**WHEELING PLAN COMMISSION
THURSDAY, JANUARY 14, 2016 6:30 P.M.**

REQUEST FOR PLAN COMMISSION ACTION
STAFF PROJECT REVIEW

RE: **Docket No. 2015-5**
Wheeling Town Center Development
351 W. Dundee Road
**Special Use-Site Plan Approval of a Preliminary Retail &
Residential Planned Unit Development**

To: Andrew Jennings, Director of Community Development
Brooke Jones, Senior Planner
Jon Tack, Village Engineer

Sheet No:
CX-1.1

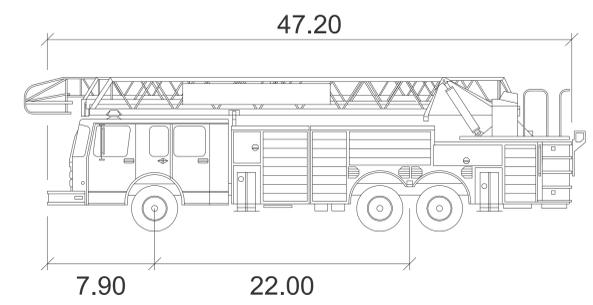
- Drawing CX-1.1 Fire Truck Movement Exhibit: The documented turning radius shows potential points of conflict within the parking lot where rear wheels of the fire apparatus will “clip” or “jump” over the curbs. This problem will be further exacerbated during periods of snow where piles of snow may exist and vehicles will not be able to fully pull into the available parking spaces. These turning radiuses must be adjusted to allow adequate turning in all types of weather and without “clipping” or “jumping” of the curb. Two (2) key areas of conflict are at the Northwest corner of Retail E where the vehicle will need to go into the straight through lane in order to turn right or “jump” the curb, as well as at the parking lot island on the West end of the project where the turning radius is only eight (8) feet.

3. Sheet CX 1.1, Fire Truck Movement will need to include the entrance and exit from the Burger King Lot.
4. The narrative "Updates from Workshop Meeting on December 10, 2015", under Challenges, second paragraph states "for the installation of an elliptical pipe that the Village intends to install". As a point of clarification the elliptical pipe will be constructed under the construction contracts for this development.

NUMBER
L1.1

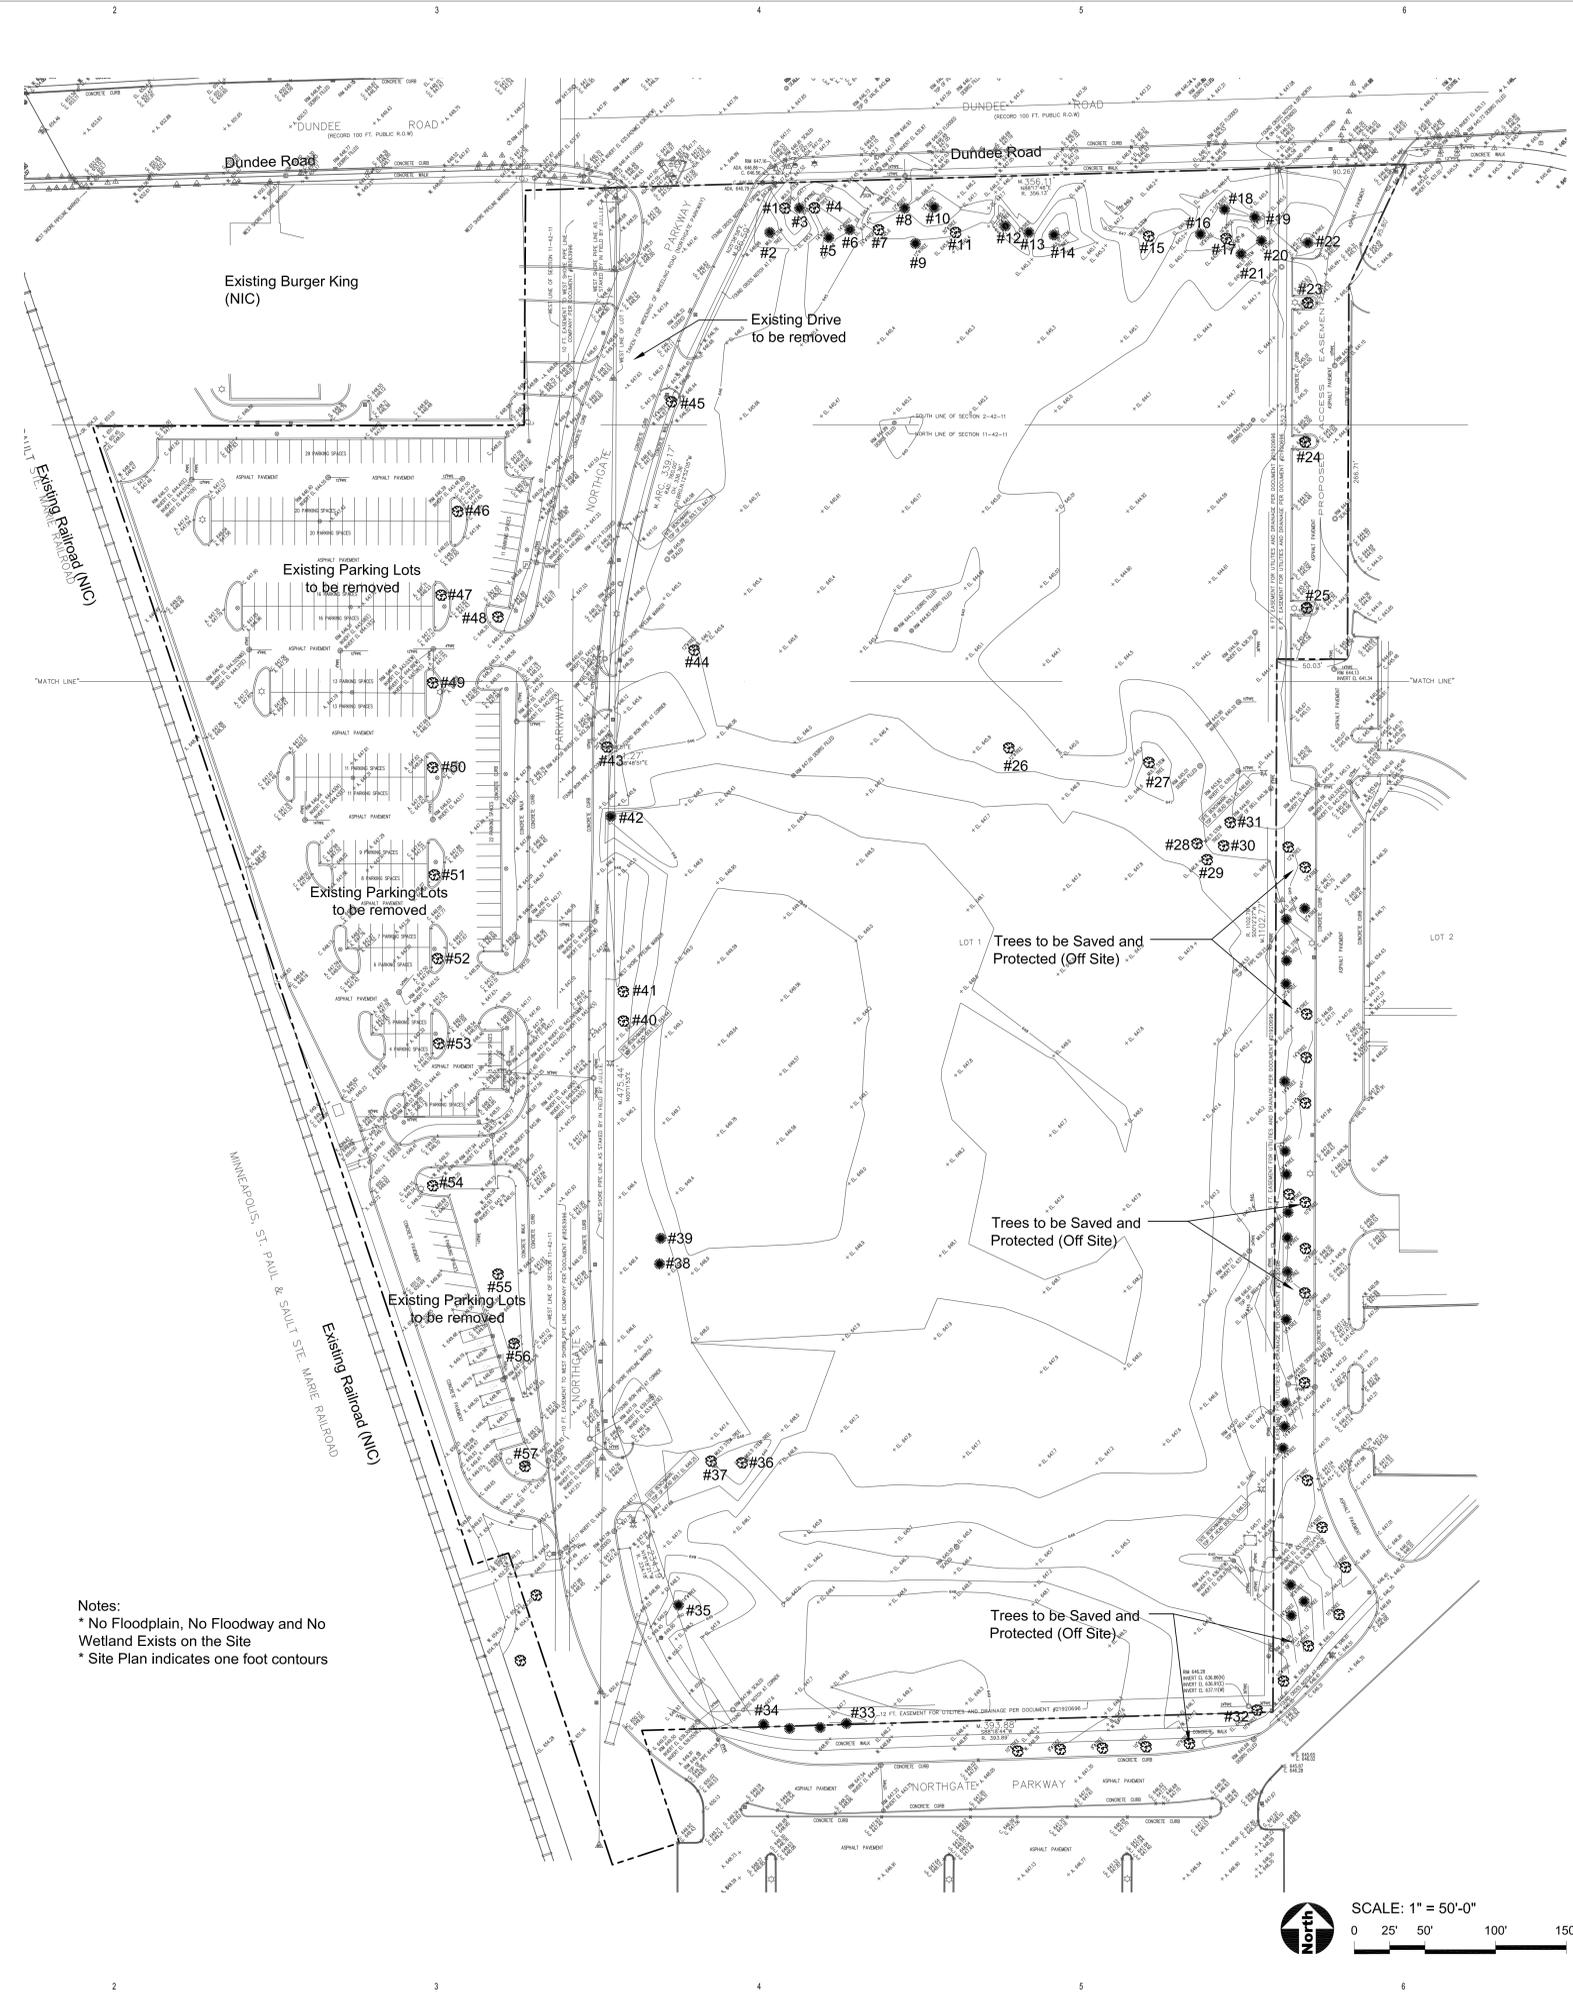
- Drawing C-3.1, C-3.2 General Landscape Plan, and L1.1 Site Plan A-100: A minimum of forty-eight (48) inches (four (4) feet) must be maintained around all fire hydrants. This open space requirement applies to both landscaping (i.e. trees, shrubs, and bushes), as well as street light stanchions. Due to the limited open space/green space associated with this project, it appears that numerous conflicts regarding landscaping/street light stanchions and fire hydrants exist. These will likely increase as the additional required fire hydrants are added to the plans. In order to resolve this matter, close coordination between the project engineers and landscape architects will be necessary.

- Drawing L1.1 General Landscape Plan: The wide path running from East to West between the cinema and the residential midrise has already been discussed as a “fire lane”. The revised landscape plan shows the inclusion of trees along the Northside of the path. Depending upon the type of trees selected, this will create an obstruction within the fire lane. As previously discussed, only miniature or low growing landscaping may be selected for this area.
